Access Compliance Report Public Rights-of-Way (Curb Ramps)

Main Street: ARTISAN_ST Cross Street: THALIA_ST Location: SW

ADA ID: RPRK211020165646 Ramp Type: Type 4 - Parallel Initial Pass/Fail: Fail Overall Compliance: No Severity Score: 15

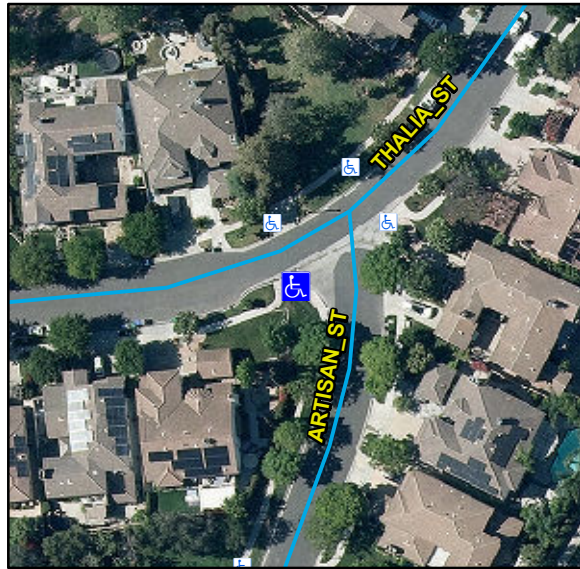
Compliance	Description	Data	Compliance	Description	Data
N/A	Ramp Length LT (in)	116	N/A	Ramp Length RT (in)	120
Yes	Ramp Width LT (in)	54	Yes	Ramp Width RT (in)	54
No	Ramp Run Slope LT (%)	10.7	Yes	Ramp Run Slope RT (%)	1.9
Yes	Ramp Cross Slope LT (%)	0.2	Yes	Ramp Cross Slope RT (%)	1.4
N/A	Landing Present	N/A	N/A	DWS Provided	N/A
N/A	Landing Length (in)	N/A	N/A	DWS Contrast	N/A
N/A	Landing Width (in)	N/A	N/A	DWS Length (in)	N/A
N/A	Landing Run Slope (%)	N/A	N/A	DWS Full Width	N/A
N/A	Landing Cross Slope (%)	N/A		DWS Offset Type	N/A
N/A	Landing Movement Obstructed?	N/A	N/A	DWS Offset Left (in)	N/A
	Landing Movement Type	N/A	N/A	DWS Offset Right (in)	N/A
N/A	Landing Shared	N/A			
N/A	Clear Space	Yes			
N/A	Clear Space To Crosswalk (in)	N/A			
N/A	Marked Crosswalk 1	No	N/A	Marked Crosswalk 2	No
	Crossing 1 Direction	E		Crossing 2 Direction	N
N/A	Marked Crosswalk 1 Width (in)	N/A		Marked Crosswalk 2 Width (in)	N/A

Remove & Replace Curb Ramp With Two New Directional Ramps or Equivalent.

R204.3, R304.3.2, STD 1115
